HISTORIC AND DESIGN REVIEW COMMISSION

HDRC CASE NO: 2016-159
ADDRESS: 1119 BURNET ST
LEGAL DESCRIPTION: NCB 1658 BLK F LOT 16
ZONING: R5 H
CITY COUNCIL DIST.: 2
DISTRICT: Dignowity Hill Historic District
APPLICANT: Gaspar Rivera
OWNER: Gaspar Rivera
TYPE OF WORK: Rehabilitation with addition
REQUEST:

The applicant is requesting a Certificate of Appropriateness for approval to:

1119 Burnet San Antonio TX. 78202

SELECTING WINDOWS FOR NEW BUILDINGS

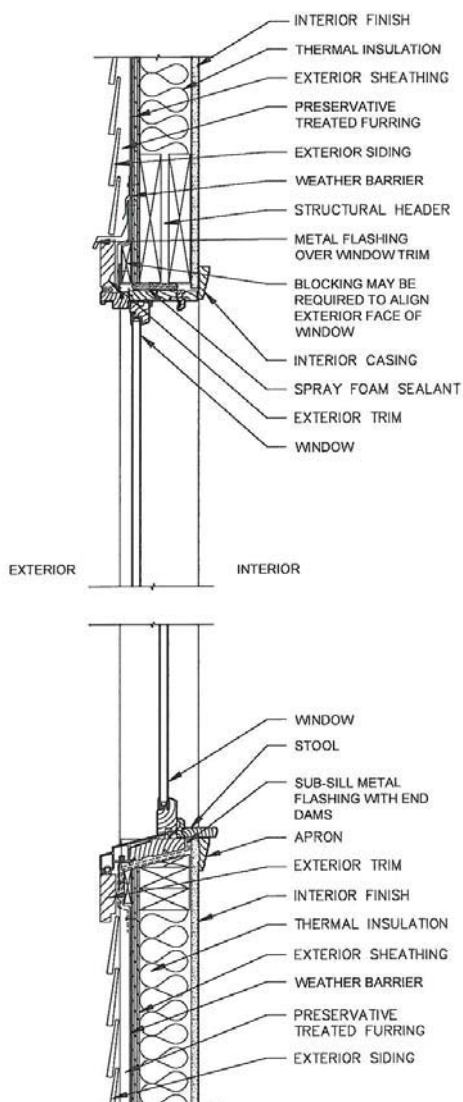
- e) According to the Guidelines for Exterior Maintenance and Alterations, original windows and doors should be preserved and maintained. When repair is not possible, an in-kind replacement is recommended. The house at 1119 Burnet currently has no windows or doors. The applicant proposes a vinyl window with a block frame that will be set within the window openings consistent with the windows policy document. Because the original windows are no longer in place, staff finds this to be an appropriate solution. Staff further finds that the installation of new wood screens would be consistent with the guidelines and aid to mask the appearance of the vinyl windows.

1. That the hipped roof form be retained instead of the proposed front gable based on finding d;
2. That wood screens be installed over the proposed windows based on finding e;
3. That the proposed front porch feature a simple shed roof that terminates below the existing cornice based on finding f; and
4. That the applicant submit detail regarding the proposed skirting that illustrates conformance with the historic design guidelines based on finding g;

Schematic Design
1119 Burnet

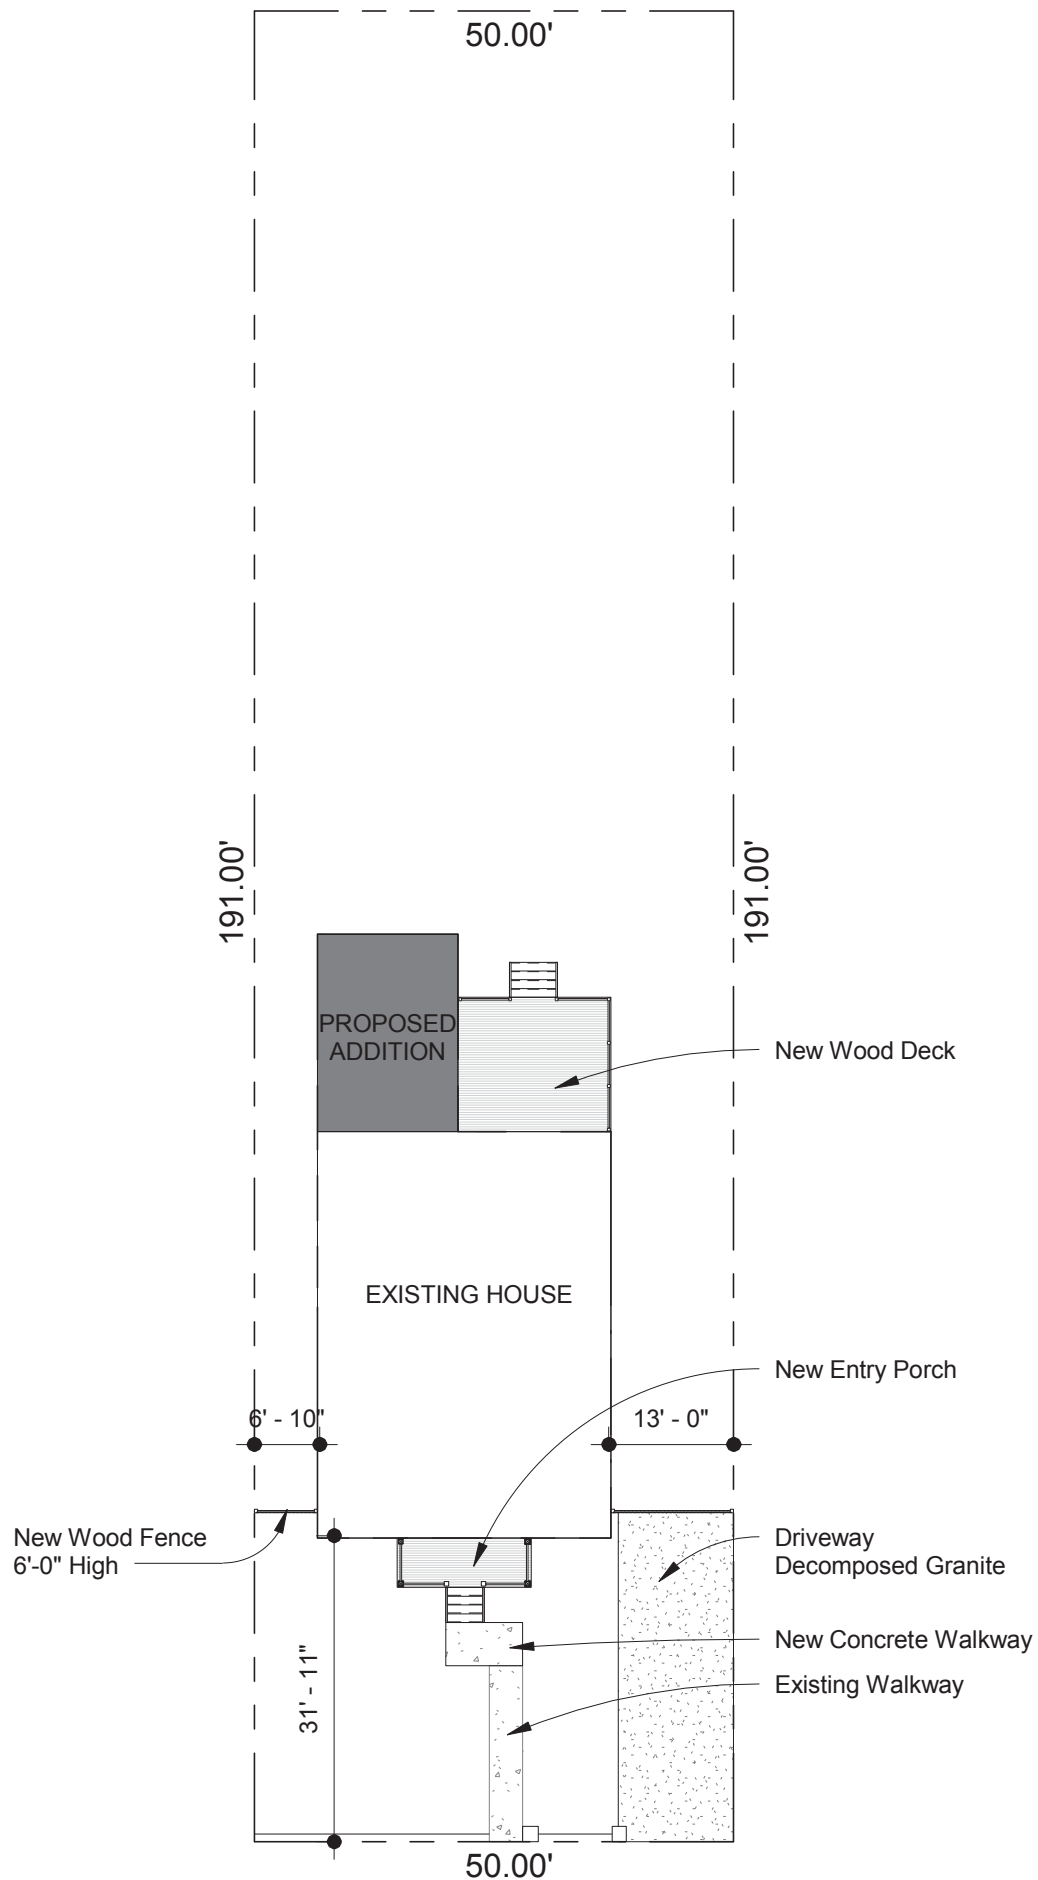
- h) The proposed rear addition is consistent with the Guidelines for Additions in terms of location, roof form, scale, and materials. The applicant has agreed to install a wood transition piece at the addition to distinguish the old from the new. This is consistent with the guidelines.

Site Plan

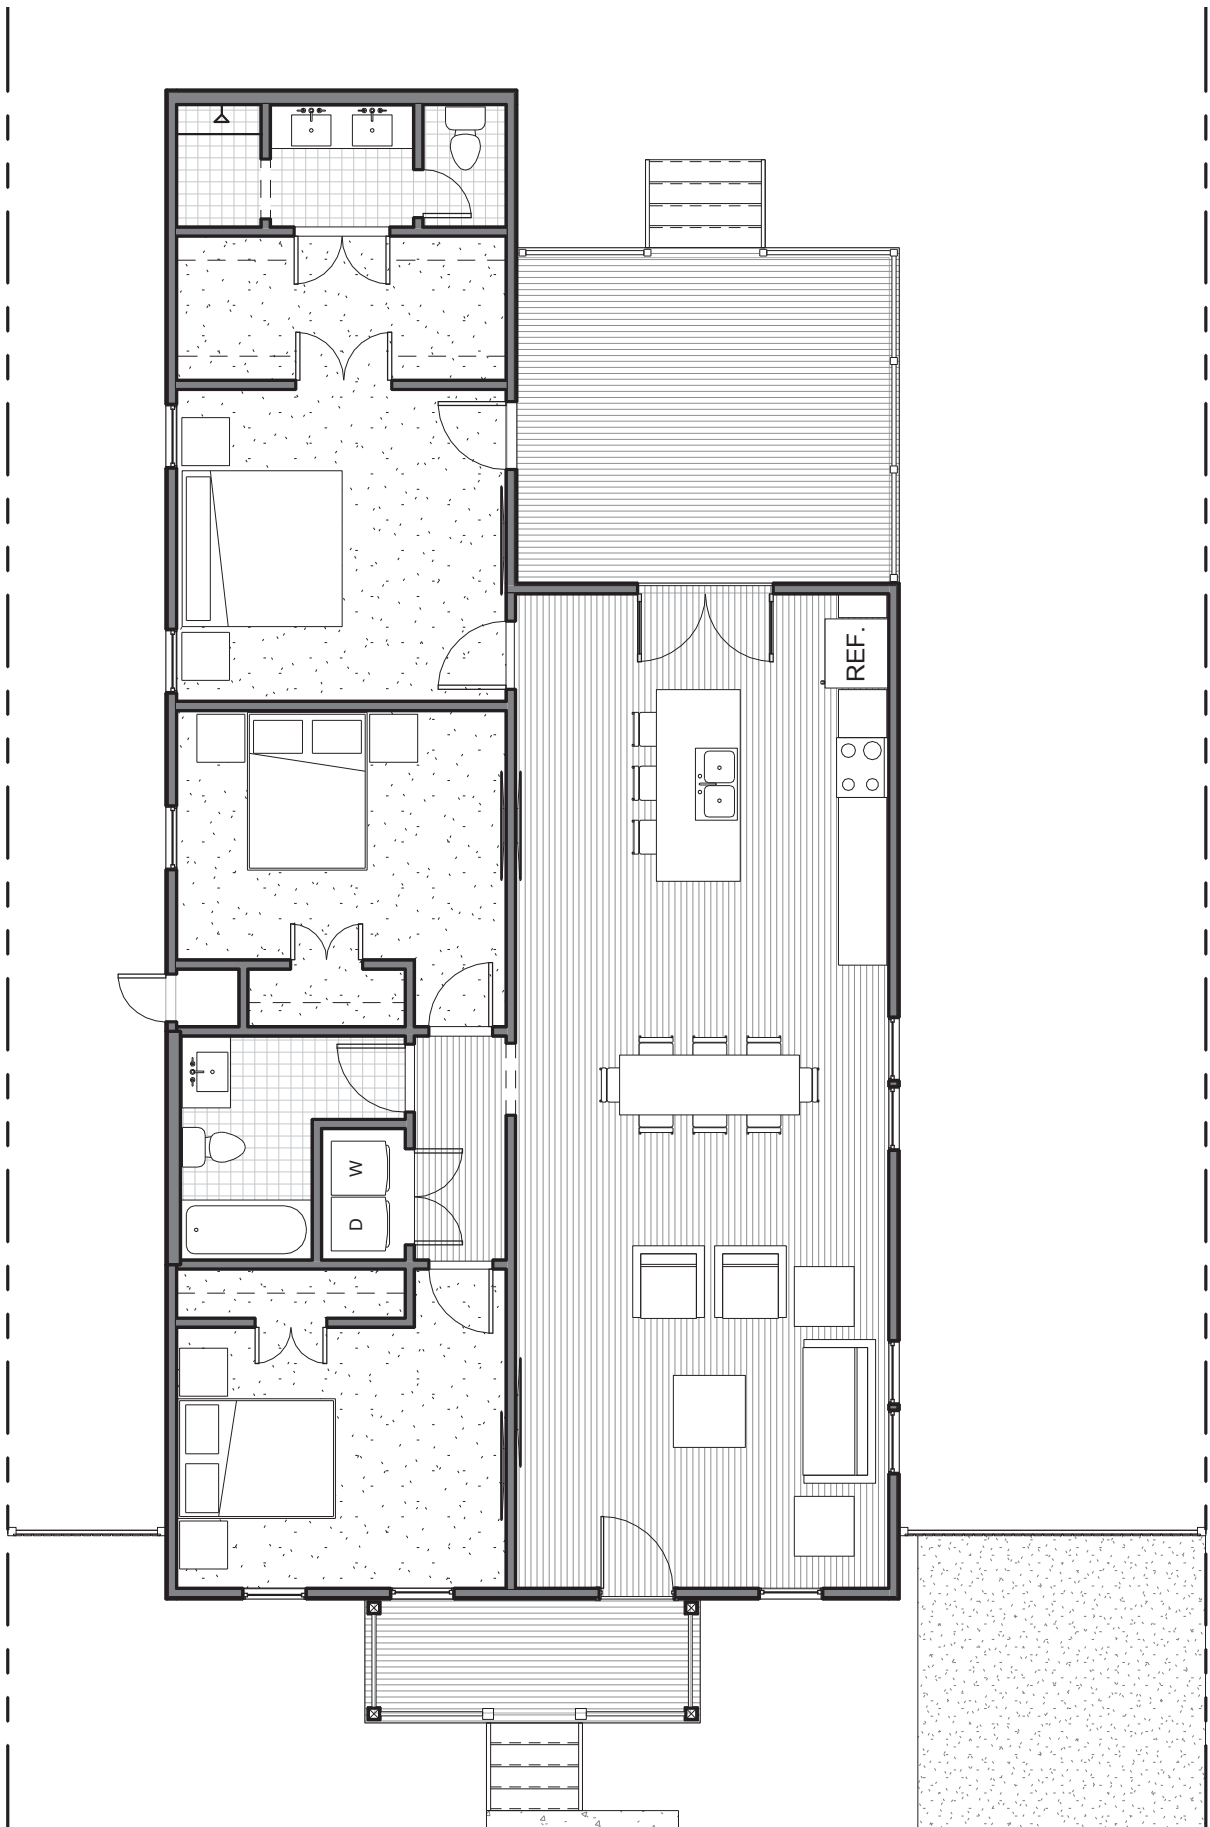
- i) The proposed rear deck, fencing, and site elements are generally consistent with the Historic Design Guidelines.

1 South
1/8" = 1'-0"

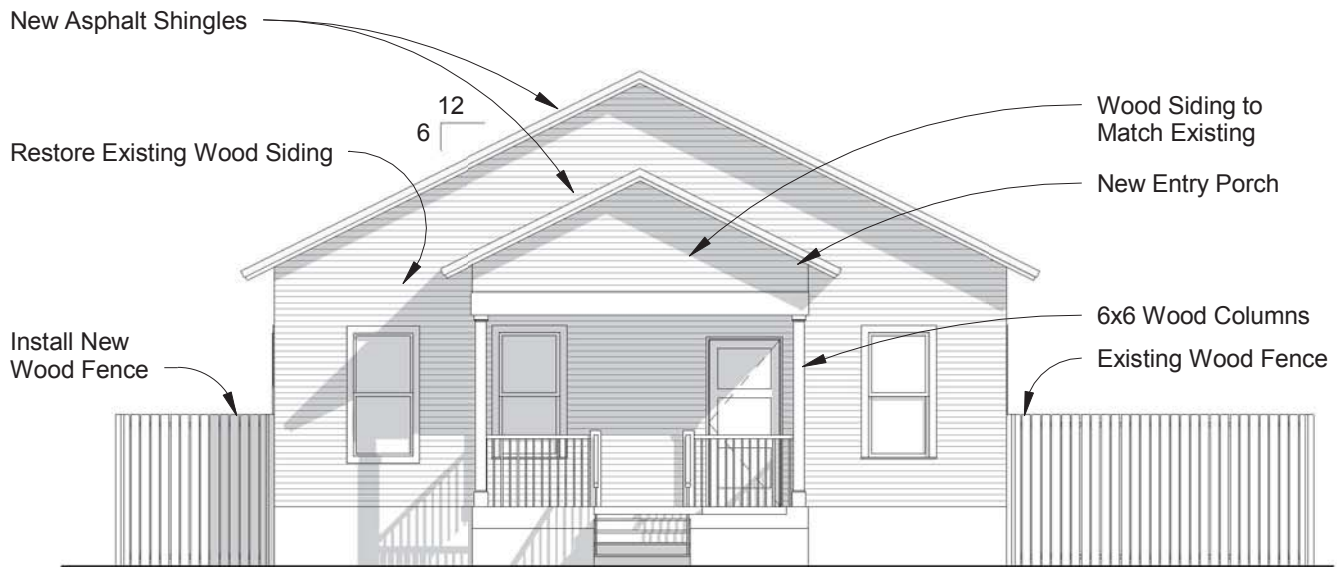
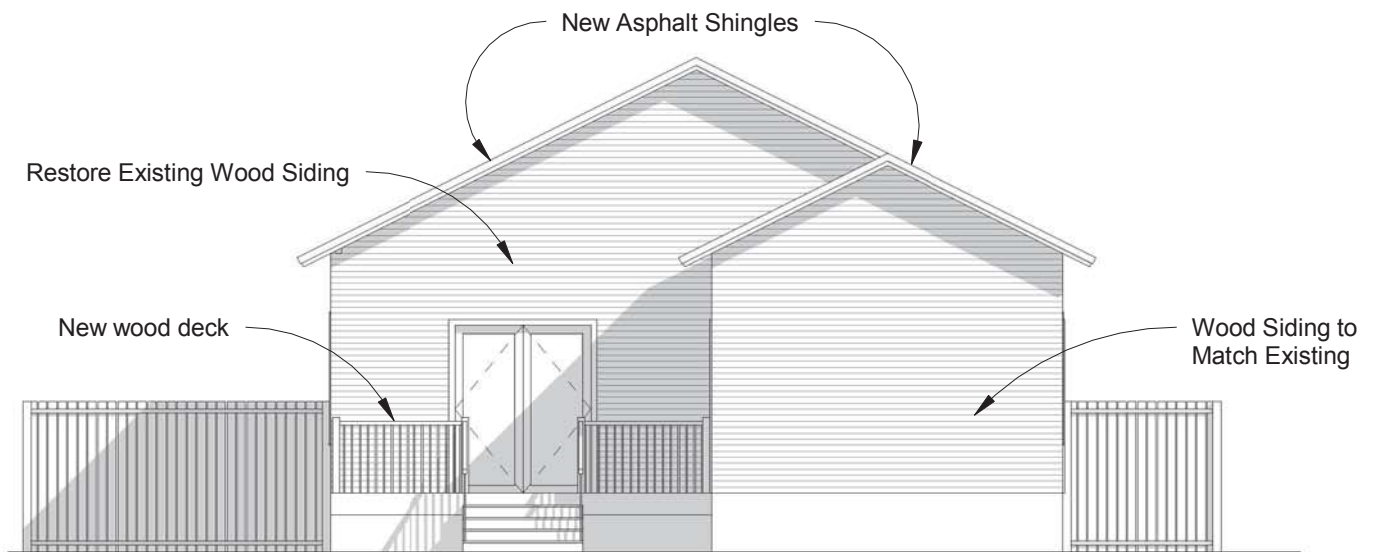
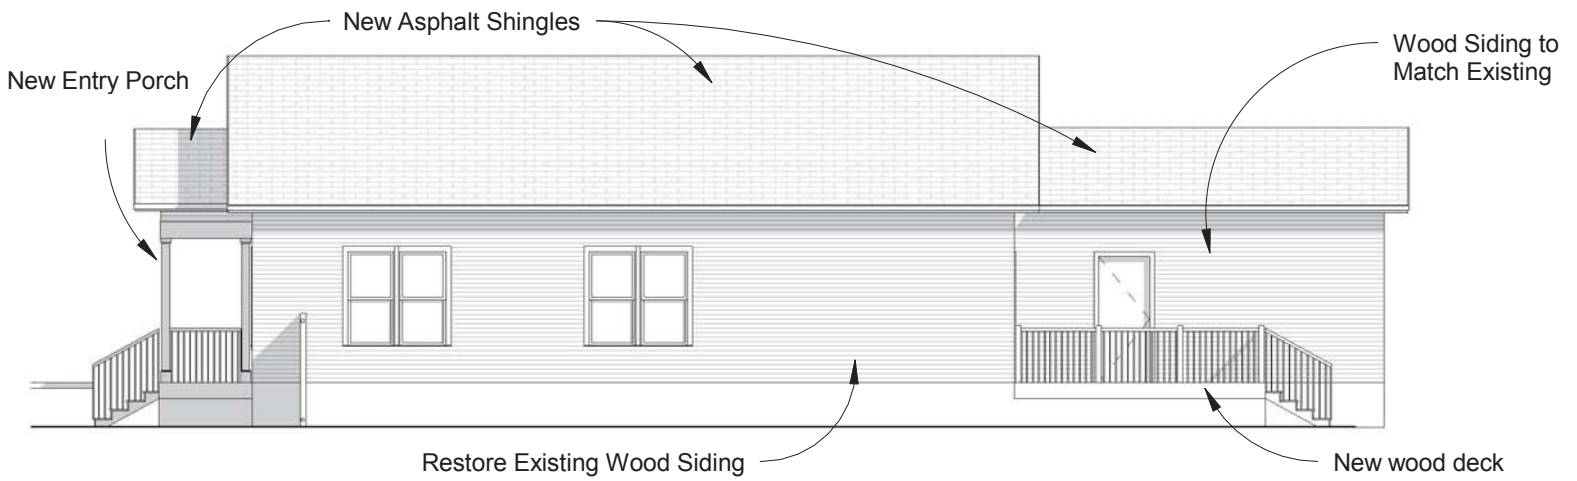
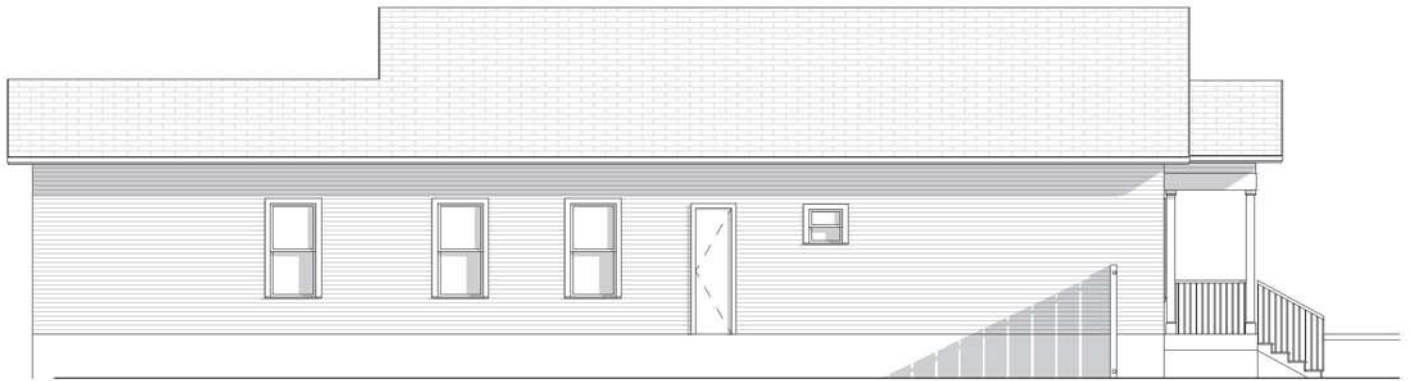
- d) According to the Guidelines for Exterior Maintenance and Alterations, original roof forms and materials should be preserved. Because the house is believed to have originally been a hipped roof, the proposed front gable is not consistent with the guidelines and is not appropriate. The proposed asphalt shingles are consistent with the guidelines.

- f) According to the Guidelines for Exterior Maintenance and Alterations, new front porches should be constructed based on accurate evidence of the original, such as photographs. If no such evidence exists, the design should be based on the architectural style of the building and historic patterns. Staff does not find that there is evidence of an original front porch. However, the predominance of houses in the historic district feature front porches, and the addition of a front porch that is consistent with the design of the home and nearby examples is consistent with the guidelines. However, as submitted, the proposed front-gable design is not consistent with the style of the house and would obscure the architectural cornice detail on the front façade. Staff finds that a simple shed roof would be more appropriate.

COMMENTS/CONCERNS: Horse has no roof. Expanding to
a 3:2 horse. Will try to keep exterior materials
in place. Only a shell exists; no windows/doors.
MG- Source detail indicates hipped roof; likely the original
condition. Addition is subordinate; recommends a ~~dark~~ transition
piece. Vinyl windows okay if set in frame per window policy.
Skirting material proposed to be hardi panel. MG- Hardi
planks recommended - ~~dark~~ smooth finish. Staff should consult
